City of Biddeford Planning Board

February 5, 2025 at 6:00 PM
City Hall Council Chambers & Zoom

PLANNING BOARD STAFF REPORT

RE: 2025.03 Sketch Plan for Reveler LLC – Proposed development of existing building into 11 residential units and a Subdivision Amendment at 2 York Street (Tax Map 71, Lot 6-2) in the MSRD-3 Zone.

Pepperill Mill – Bldg. # 30 – 2 York Street – Site Plan with new property line in red

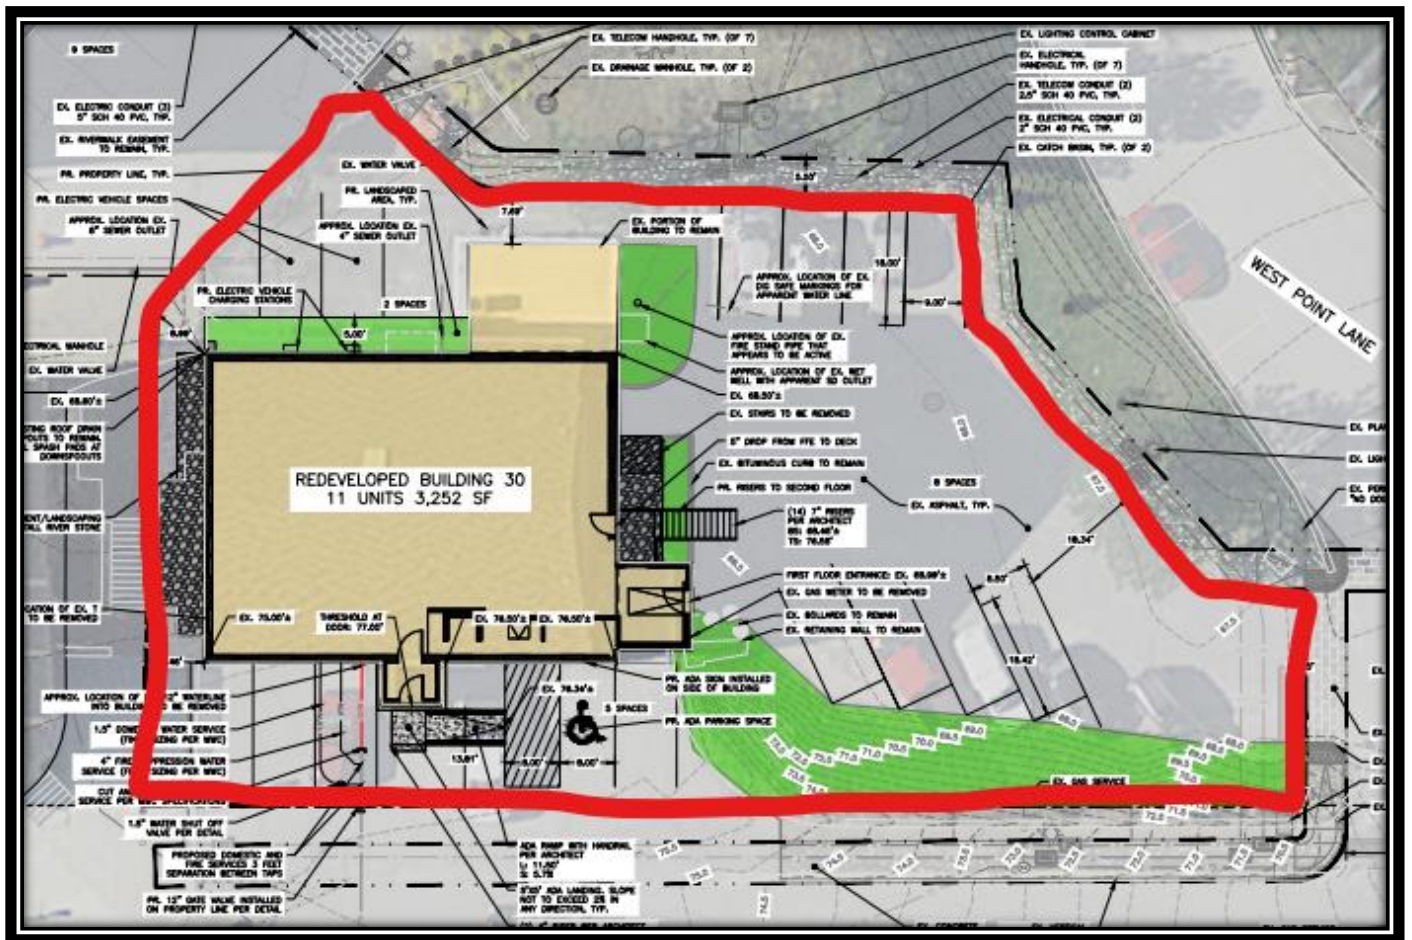
As part of the project, the Applicants are seeking to amend the existing property lines, so the new proposed lot area (12,909 square feet) would provide the property with their own designated / controlled parking and some landscaped areas. The property line adjustment would include the existing parking areas to the front, east side and rear of the building. The property lines being proposed would allow this development to be “separated” from Pepperill Mill and provide the required off-street parking for the proposed development. Staff are supportive of the proposed property line adjustment as this building and the subject parking is fairly separated from the majority of the Mill. The Lot is located in the MSRD-3. The proposed development lots would be served by public sewer systems and would connect to public water.

2 York Street - Staff Recommended Site Plan Modifications

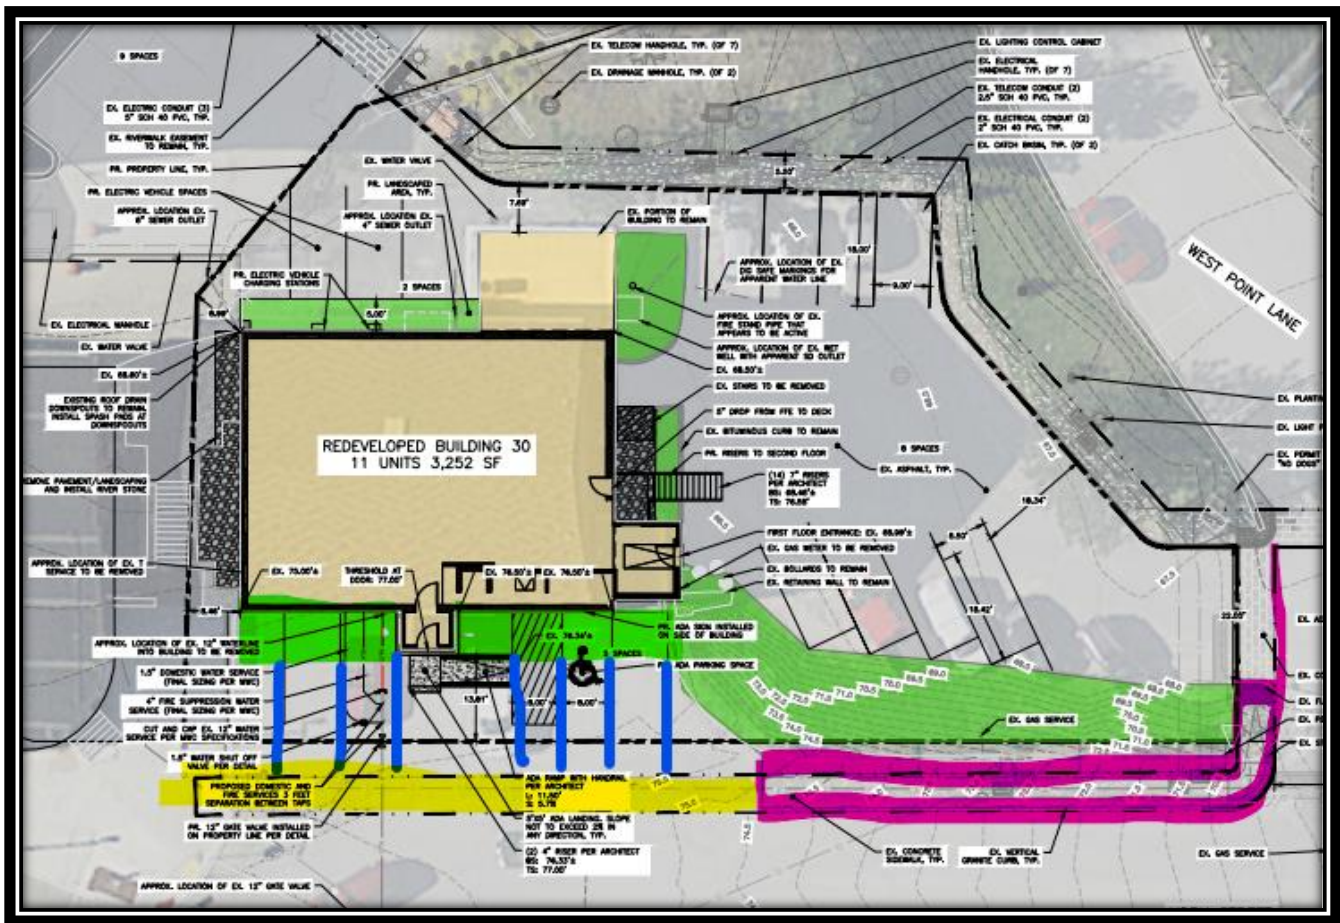
12. Possible Site Improvements: Above is a marked-up plan with the following colors:
- A. **Pink:** Existing sidewalk that was installed as part of the York and Laconia pedestrian project. The installed sidewalk is concrete, and the curb is granite.

- C. **Green:** I would like to see if we can incorporate some landscape plantings at the front foundation. This would require us to move the parking stalls back toward York Street and terminating at the new proposed sidewalk (yellow).
